SMDC Planning Reference –	SMD/2023/0594		
Site Name –	Blythe House Farm Solar Facility (extension)		
Summary of proposals -	Photo voltaic array facility with control equipment		
Consultation Note Subject –	Landscape and Visual Matters		
Planning Case Officer –	Declan Cleary		
Landscape Comments Prepared By –	Stuart Ryder of Ryder Landscape Consultants		
Date of site visit —	7/2/24	Date of response	20/2/24
Recommendation –	Approval – Subject to design amendments to the upper fields arrangements.

Blythe House Farm Solar Facility Extension – Landscape and Visual Consultation Note

For the sake of this description and discussion of other effects the seven fields have been numbered 1 to 7 as per the diagram below.

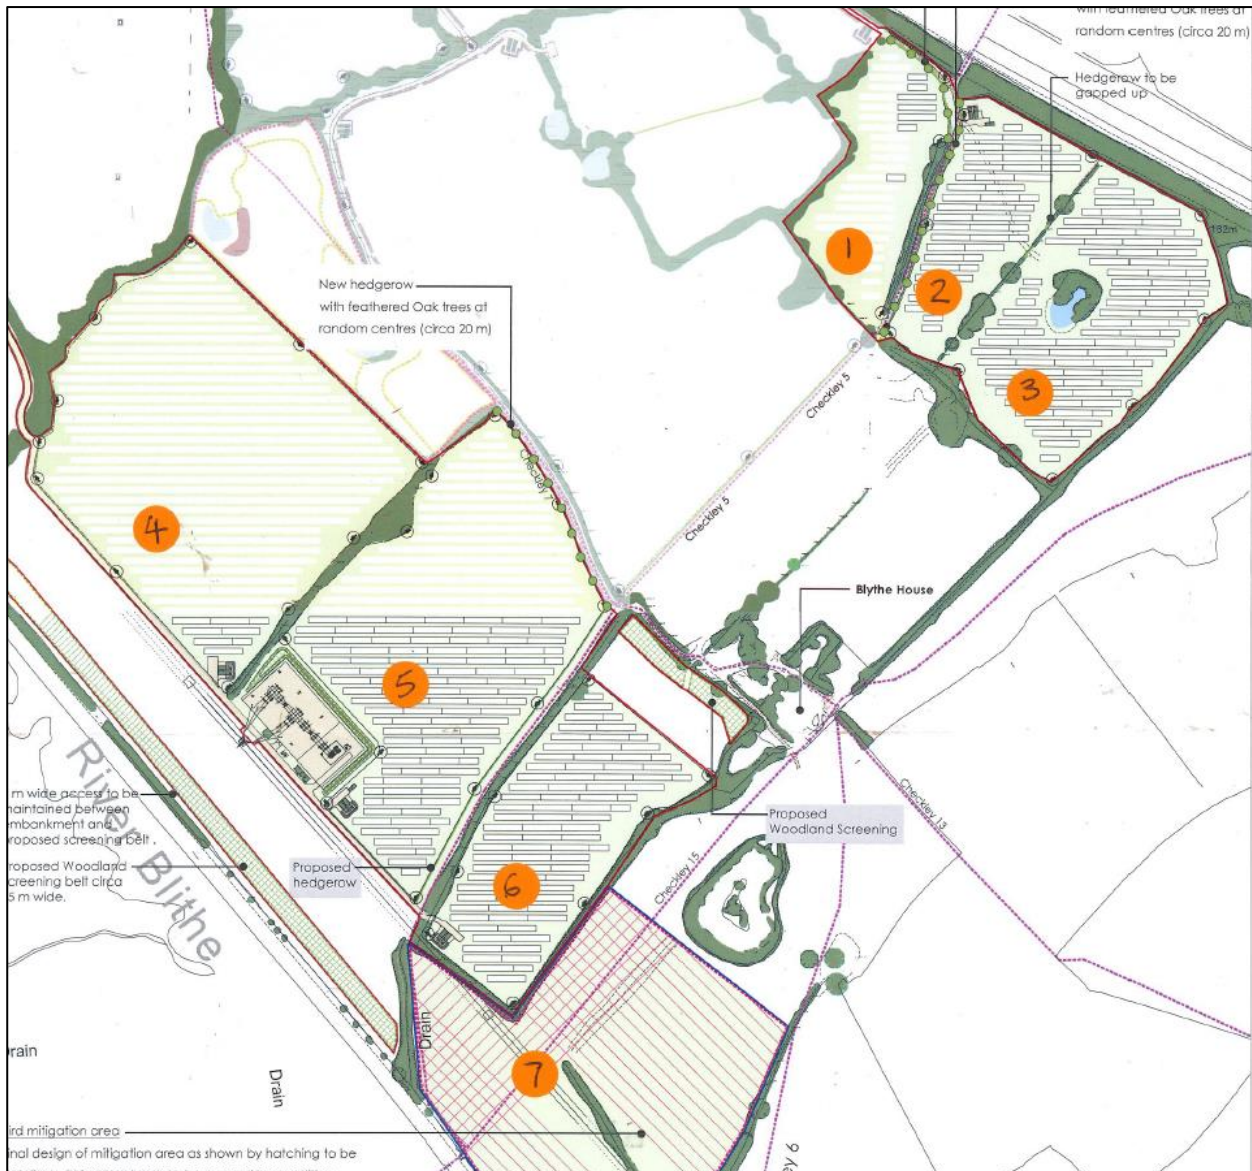
The first three fields (Nos 1-3) reached after crossing the A50 would have relatively small collections of arrays situated in them. The apparent edges to the arrays appear to respect the mature hedge and tree root protection areas. No tree or hedgerow removal is indicated for the northern fields and a new hedgerow is proposed for the small field (Field 1) to the west of the farm access road and gapping up to the hedgerow that separates the two fields (Fields 2 & 3) to the east of the access road. No internal roads within the arrays are indicated.

Field 4 is the largest of all of the application fields and is proposed to be set entirely with arrays.

Field 5 is also large and its south west portion is where the DNO and Customer sub-stations would be set to connect to the national grid. Presumably an access track is put to the east of this field's boundary to allow access to the sub-stations.

Field 6 is also put to arrays to the south of the cordon sanitaire.

Finally Field 7 which appears as two field parcels on the ground largely divided by an outgrown hedgerow is set as a 'bird mitigation area' with a drawing label explaining its final design to be secured by conditioning a LEMP / BEMP. It currently stands as a field of improved pasture. It does however have the purpose dug angling lake to the north of it which is set in a ring of native and ornamental planting to provide shelter and amenity to those fishing there.

Of all the sections of Checkley 5 it is the 'arrival' view across the Blithe Valley near the A50 that experiences the greatest adverse change and ideally Fields 1 & 2 should be left open and free of arrays so long views over them can be retained.

- Removal of arrays from Fields 1 & 2 to retain the attractive cross valley view to the other side of the Blithe Valley.
- Look to use Fields 1 & 2 as the bird mitigation fields associated with the proposals.

- Consider locating arrays from Fields 1 & 2 in the southern part of Field 7 where their presence is less visually intrusive.
- Confirmation of long-term management of valuable landscape features (also ecological assets) of hedgerows, field pond and conversion of nutrient rich mono-culture grass sward to the bird mitigation area; and
- Confirming the positions and widths of the access route through the various hedgerows including how the fields, or areas where no arrays are proposed are accessed.
